## **Iditarod Dog Sledding Historic District (IDSHD) Workshop Workshop Summary and Implementation Plan Summary Comment Resolution**

In accordance with the Section 106 Programmatic Agreement for the Port MacKenzie Rail Extension (PMRE) project, the Alaska Railroad Corporation (ARRC) hosted two of three planned Iditarod Dog Sledding Historic District (IDSHD) workshops in June and July 2011. At the request of IDSHD workshop participants, the Matanuska-Susitna Borough (MSB) hosted a larger trail user meeting in October 2011. ARRC and MSB, hereafter referred to collectively as the Project Team, have worked closely to identify design changes, modifications, and/or refinements to the project that will address concerns and mitigate impacts identified during those meetings. This document summarizes meeting/workshop participants' comments and concerns, and provides the Project Team's proposed resolution. In January 2012, ARRC will host a final IDSHD Workshop, and this document will serve as the basis for discussing how mushers' (and other trail users') comments and concerns have been addressed. Following that meeting, ARRC will prepare a *Workshop Summary and Implementation Plan* for submit

Figure 1: Crossing constraints

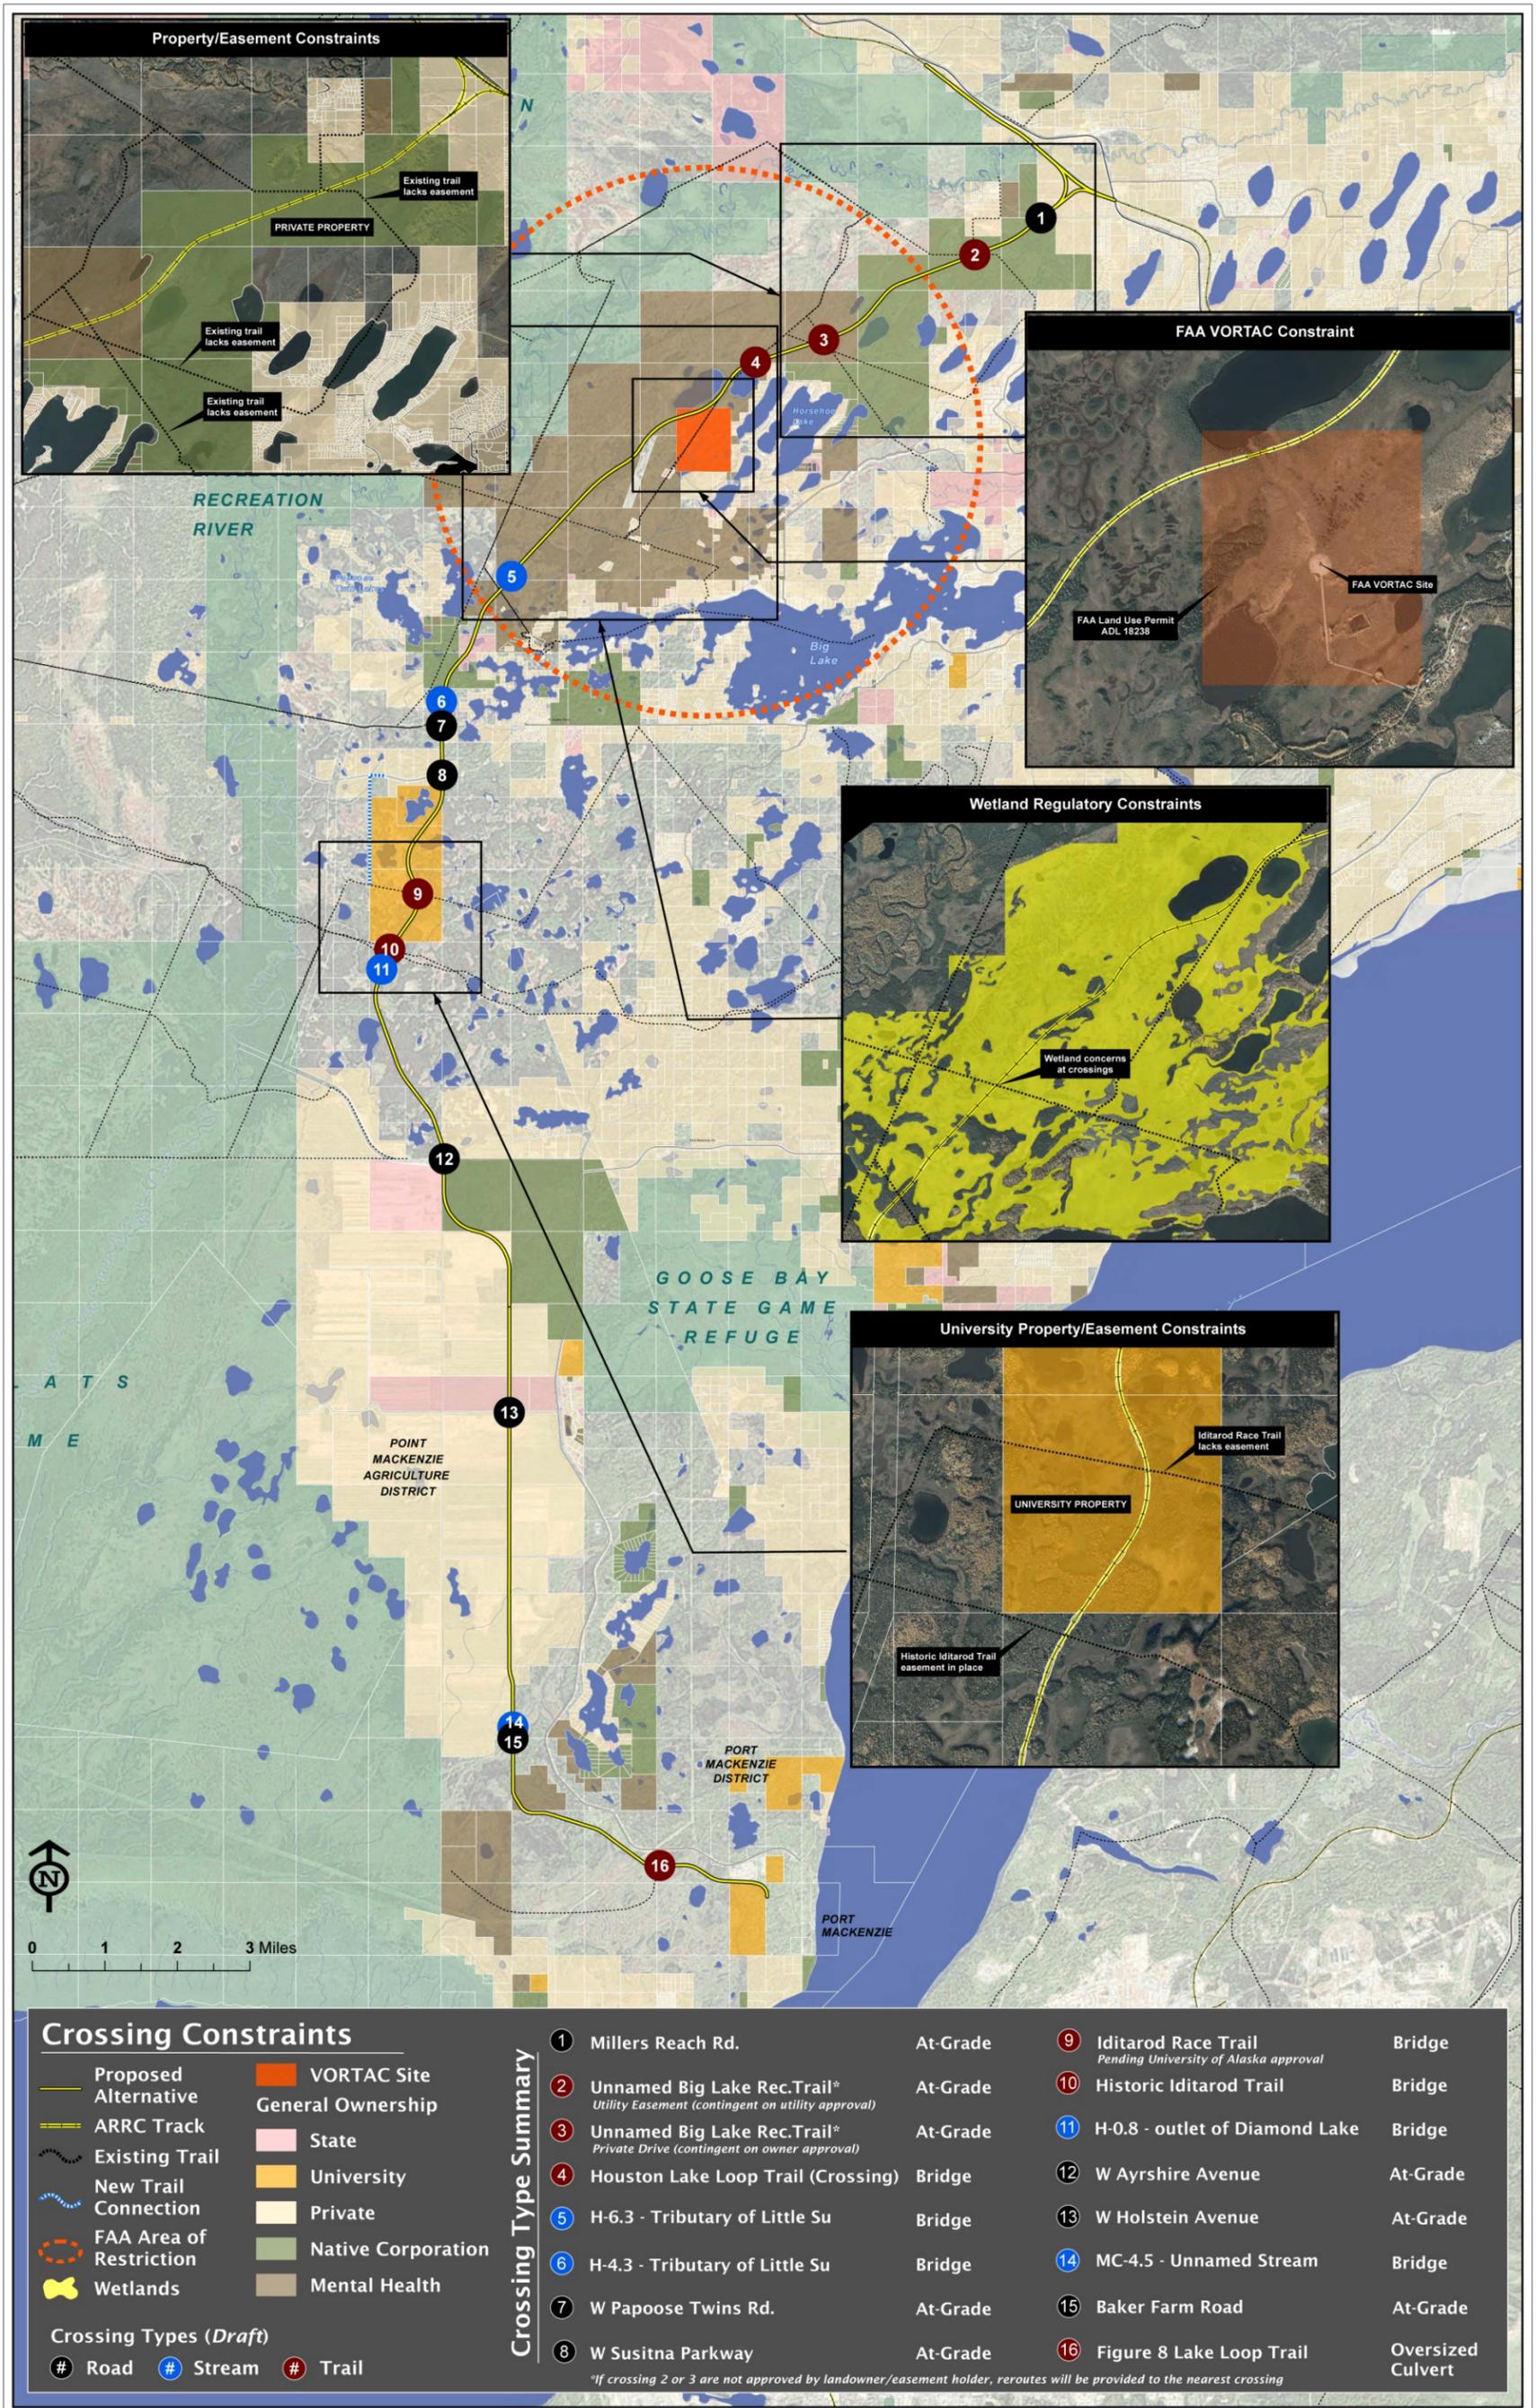
- 6. Provide a map to workshop participants showing where crossings cannot be located (e.g., VORTAC or wetland restrictions or other design concerns).*

**Proposed Resolution:** A map showing restrictions/constraints limiting crossing locations was available at the MSB Trail User Open House (10/27/11). This map was posted on the

project website ([http://www.portmacrail.com/maps/Constraints\\_v2%20web.jpg](http://www.portmacrail.com/maps/Constraints_v2%20web.jpg)) and is included in this document (see Figure 1 in Attachment 1).

The Project Team continues to work with the Federal Aviation Administration (FAA) regarding project and construction constraints associated with the FAA VORTAC radar site, which controls the approach for all Anchorage air traffic. FAA defined a three-mile radius where construction restrictions will apply (see Figure 1 in Attachment 1). Within this restricted area, the rail embankment and passing trains cannot block the VORTAC electronic signals. These restrictions include minimizing the height and/or geometry of the rail embankment and associated crossing structures in the vicinity of the VORTAC. This constraint has resulted in the loss of one previously planned crossing as the height over the Outflow of Muleshoe Lake cannot meet the 14' of vertical clearance required. It also prevents grade separation of the Iron Dog Connector Trail to the west of the VORTAC site.

Figure 2: Crossing locations

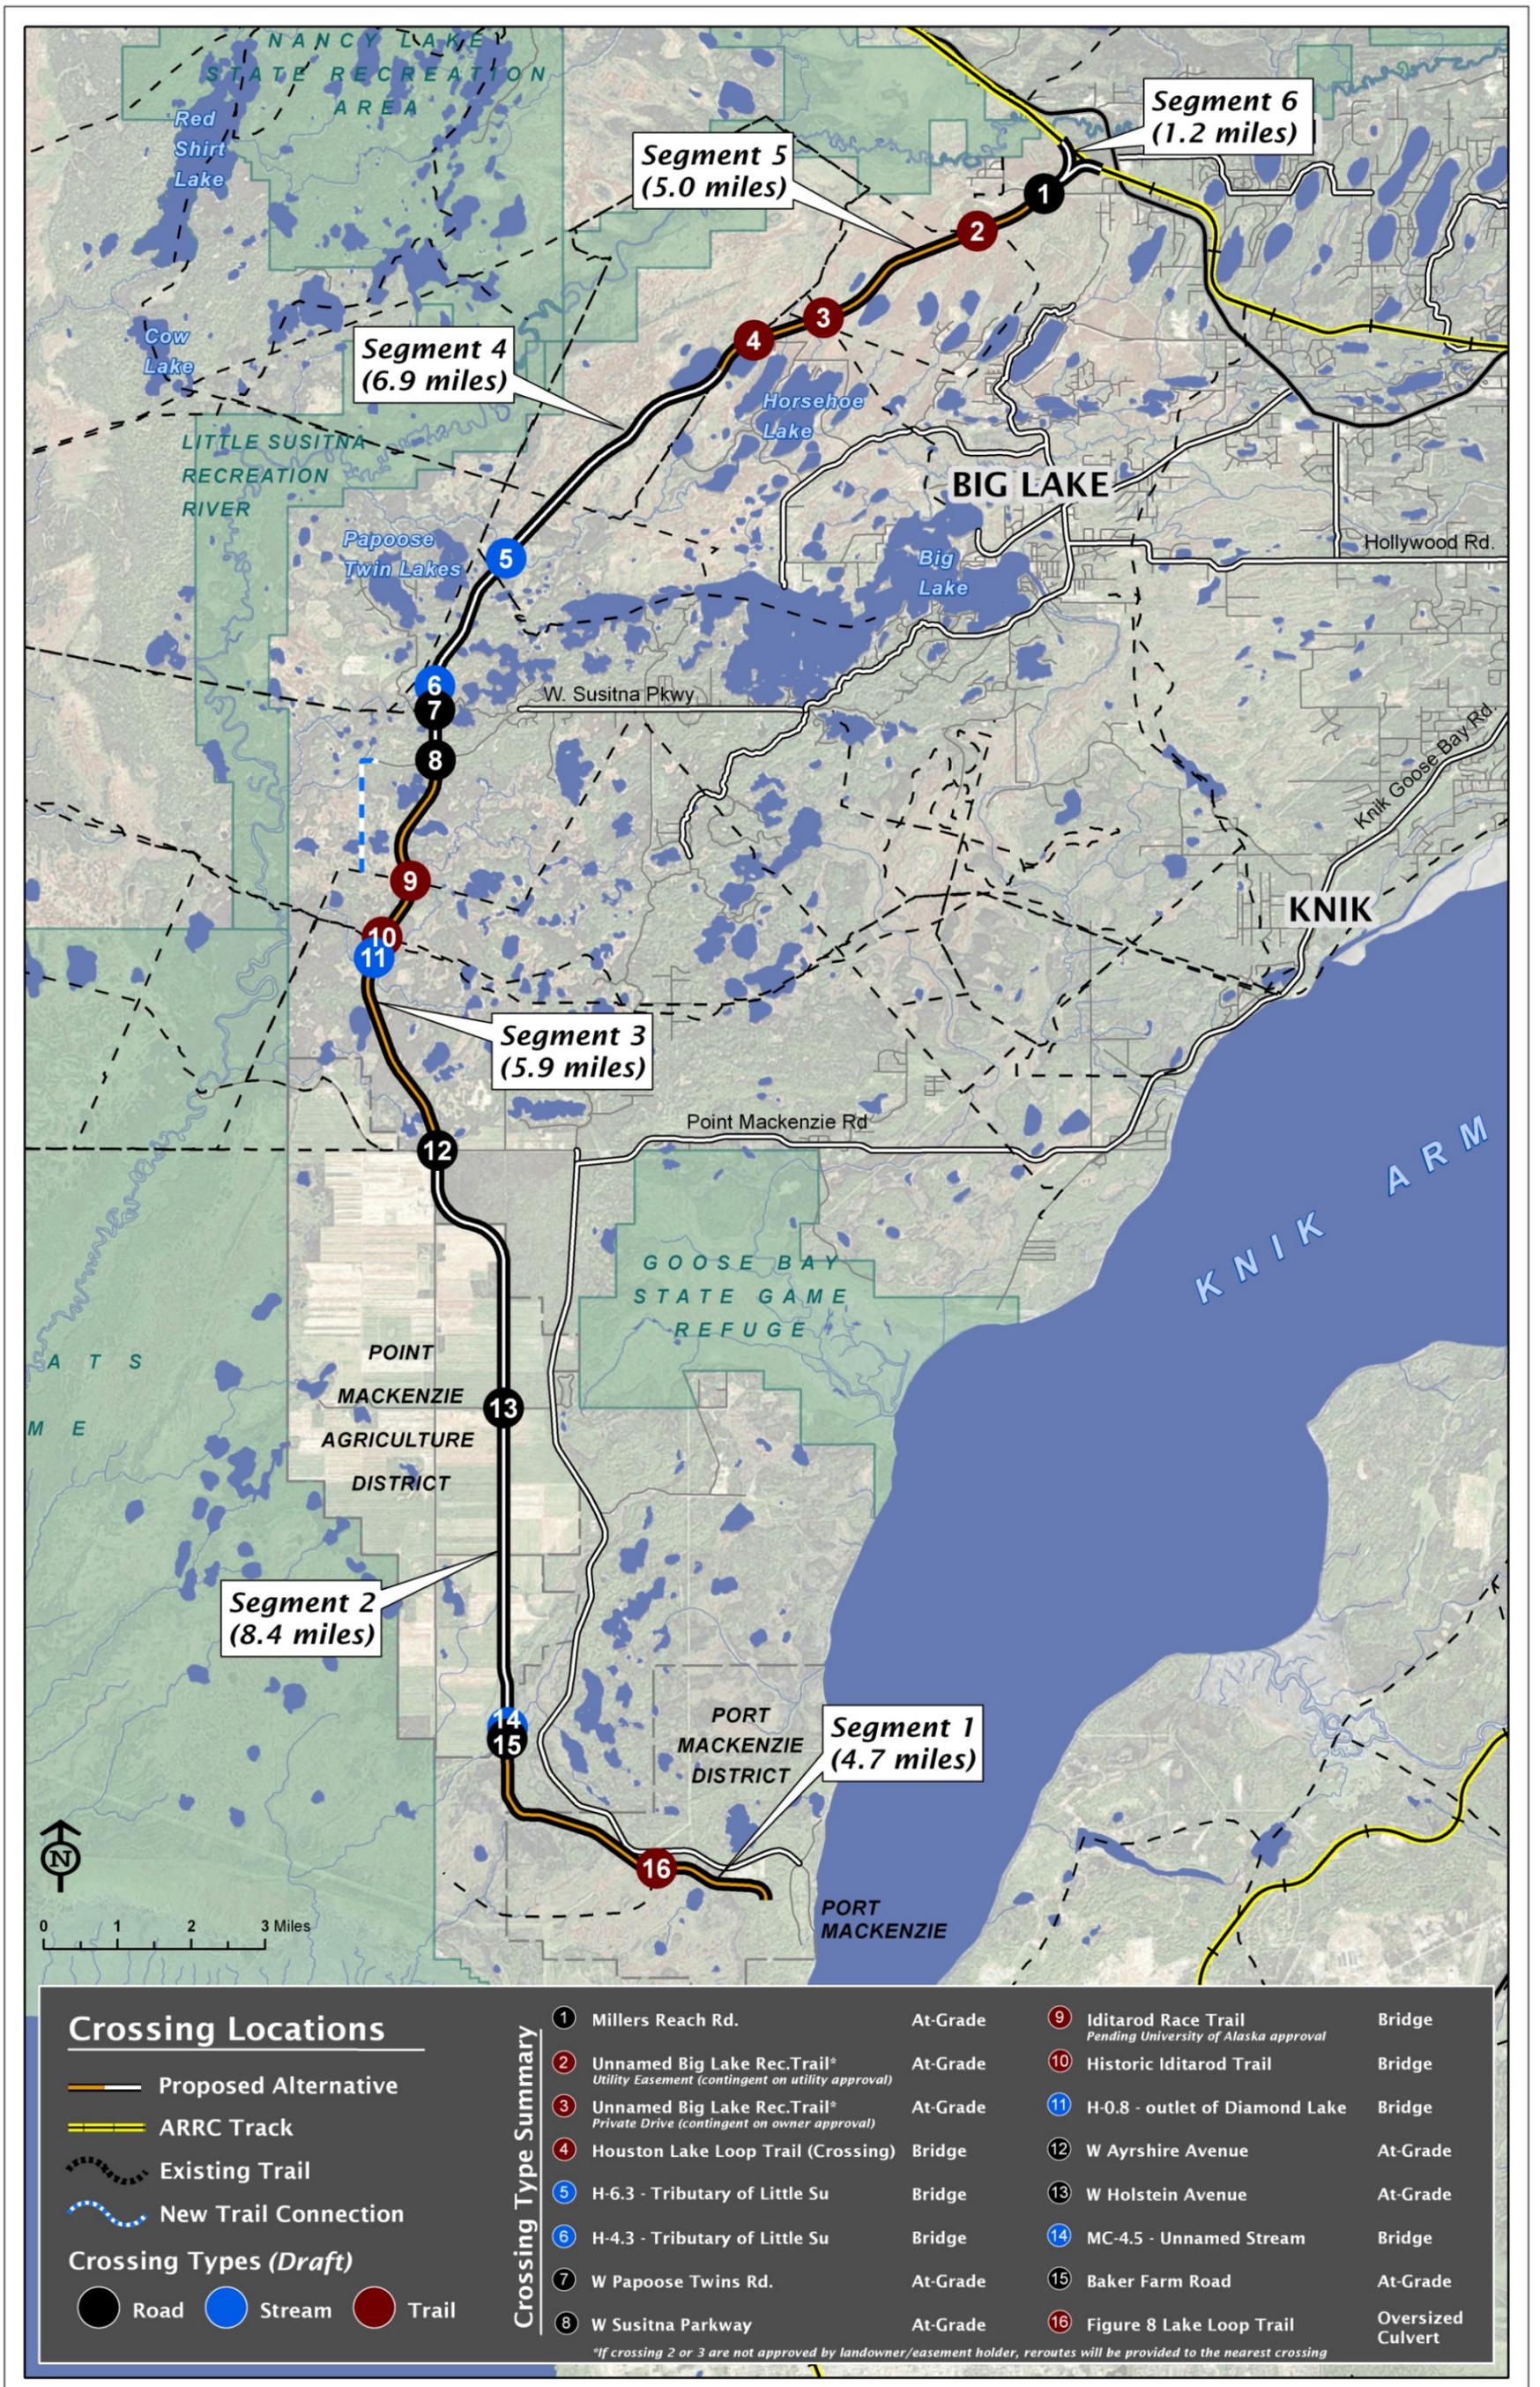
13. Add a crossing for the trail between current Crossings 12 and 13 (formerly Crossings 13 and 14) that is shown on various maps.

**Proposed Resolution:** This former trail is on agricultural land and no longer exists, although it appears on old maps and was included in the Stephen R. Braund & Associates (SRB&A) 2010 report prepared during the National Environmental Policy Act (NEPA) process. Per consultation with Workshop participants, the crossing for the trail between Crossings 12 and 13 is not needed as this trail is no longer in use. No other trail users have identified a need for a crossing at this location. An at-grade crossing at Baker Farm Road (Crossing 15) has been added to project crossing maps; however, this crossing is not currently planned for continual use. A summary of crossings is included in Table 1 and illustrated on Figure 2 of Attachment 1.
